**FINAL ENGINEERING PLANS  
FOR  
SUMMIT HOUSING GROUP - PUBLIC IMPROVEMENTS**

LYONS VALLEY PARK FILING NO. 8

**COVER SHEET  
SUMMIT HOUSING GROUP  
LYONS VALLEY PARK FILING NO. 8  
LYONS, COLORADO**

CARTER DRIVE  
ROAD PLAN AND PROFILE  
SUMMIT HOUSING GROUP  
LYONS VALLEY PARK FILING NO. 8  
LYONS, COLORADO

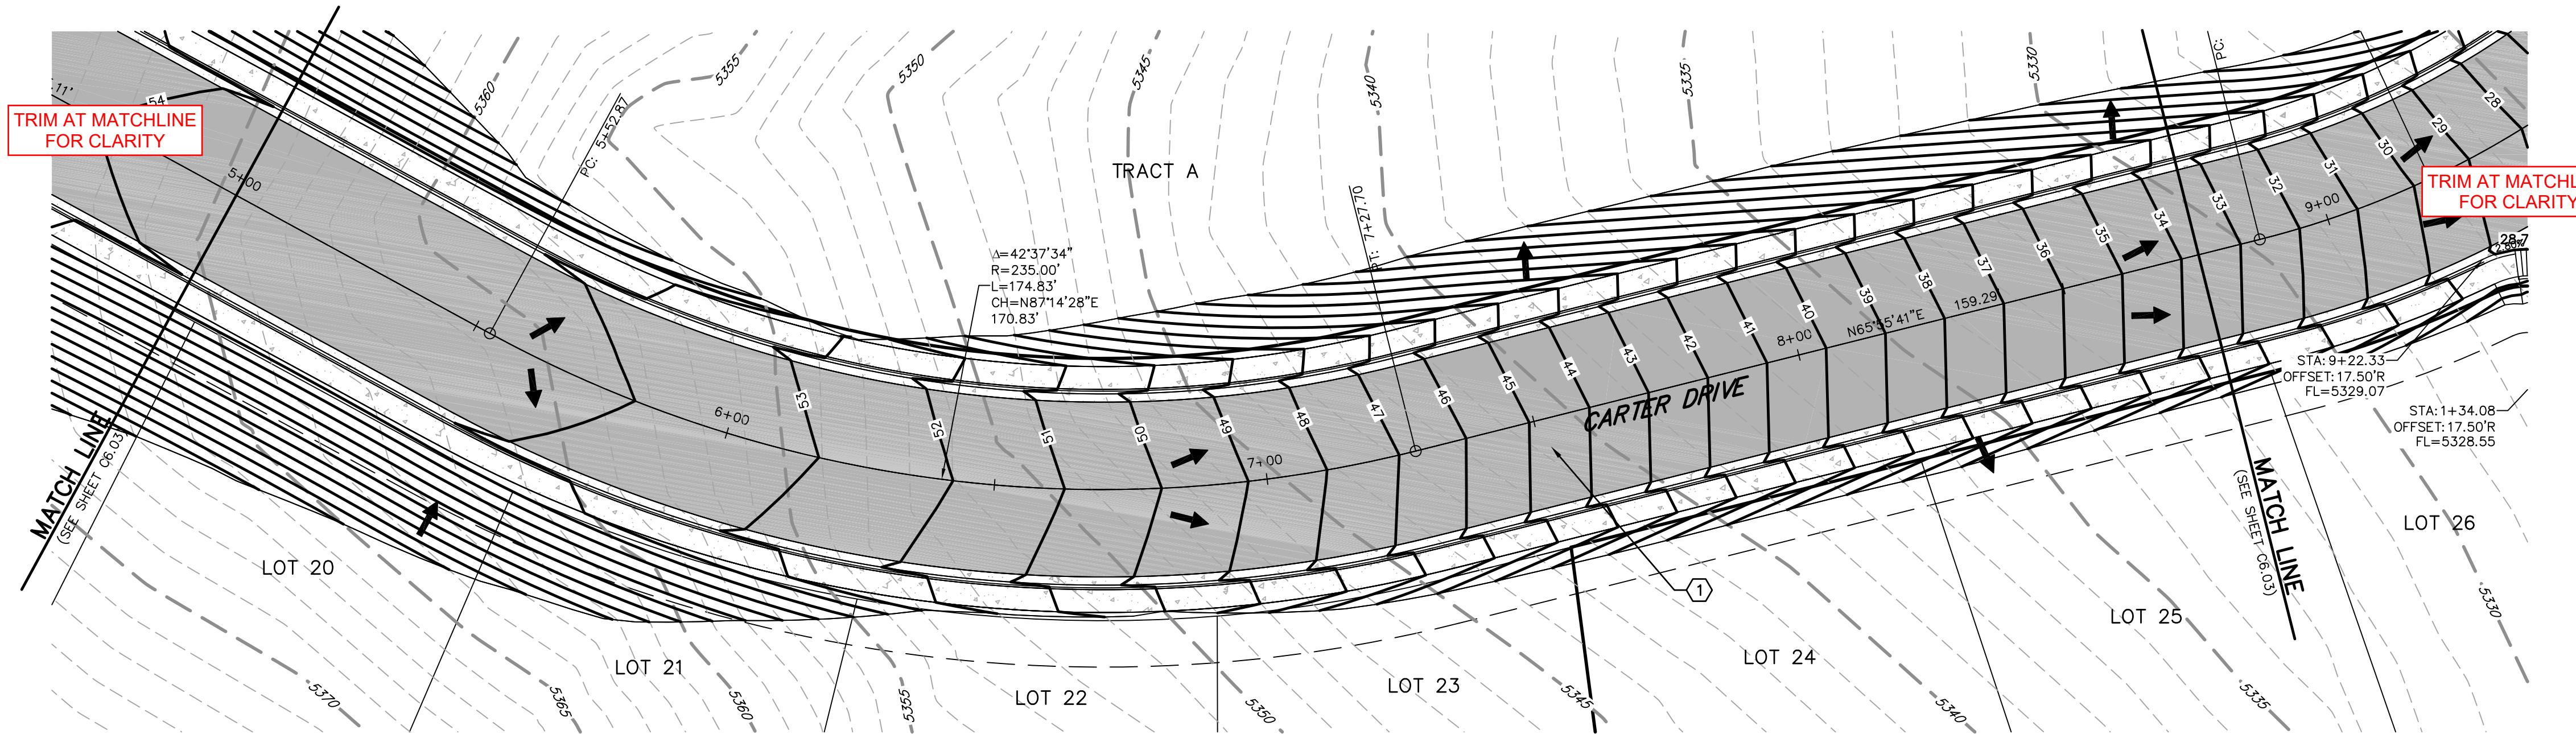
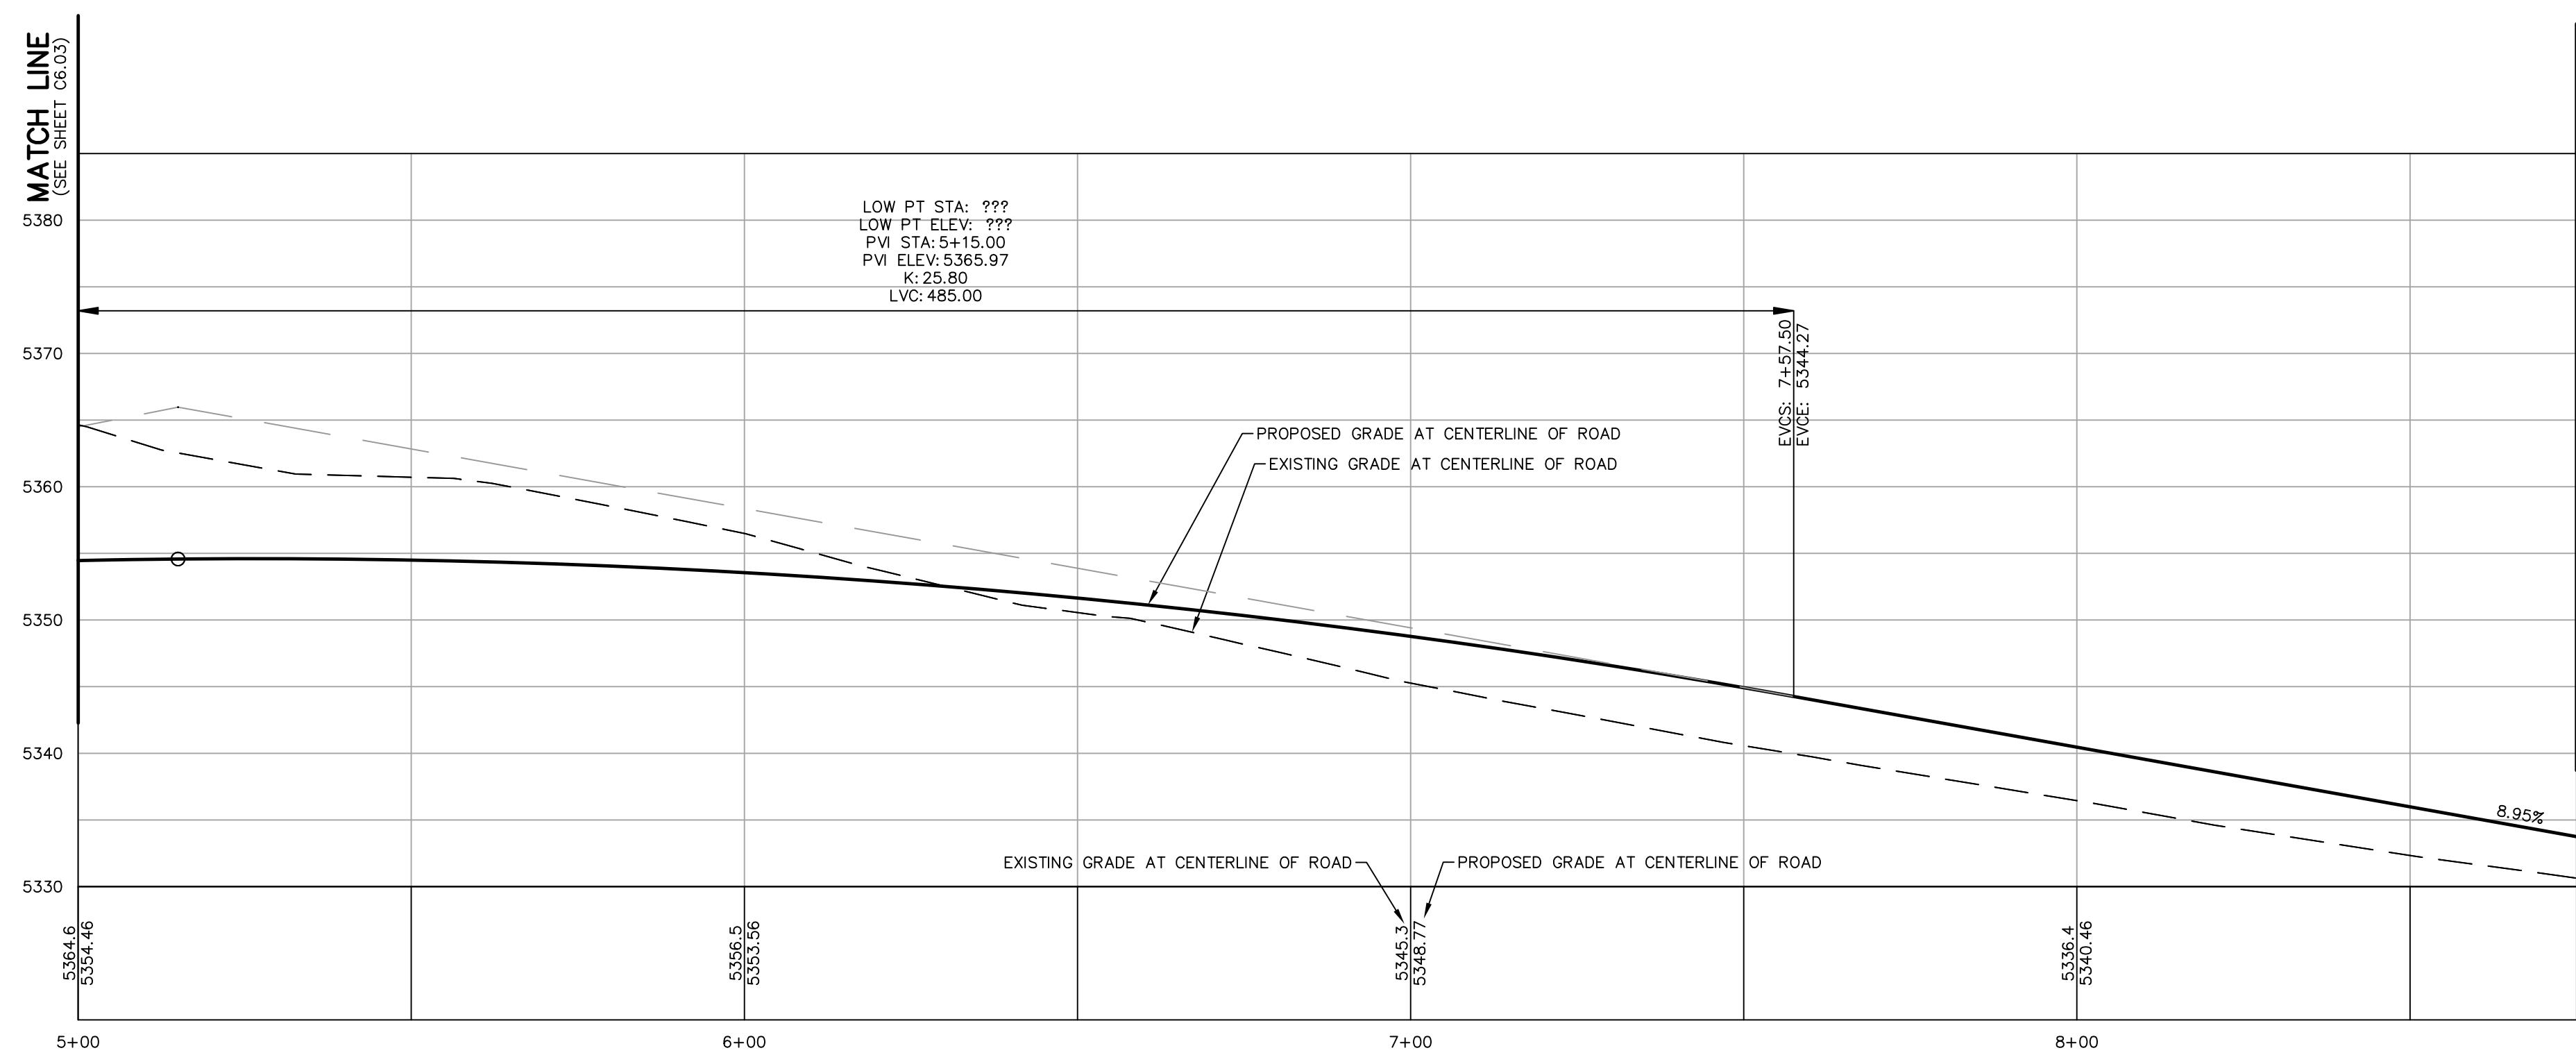
SHOW PRIVATE DRIVE/DRIVEWAY LOCATIONS TO BE  
CONSTRUCTED FOR TRACT A AT A MINIMUM TO PREVENT  
NEWLY CONSTRUCTED SIDEWALK FROM BEING REPLACED  
TO CONSTRUCT THICKER DRIVEWAY SECTIONS.
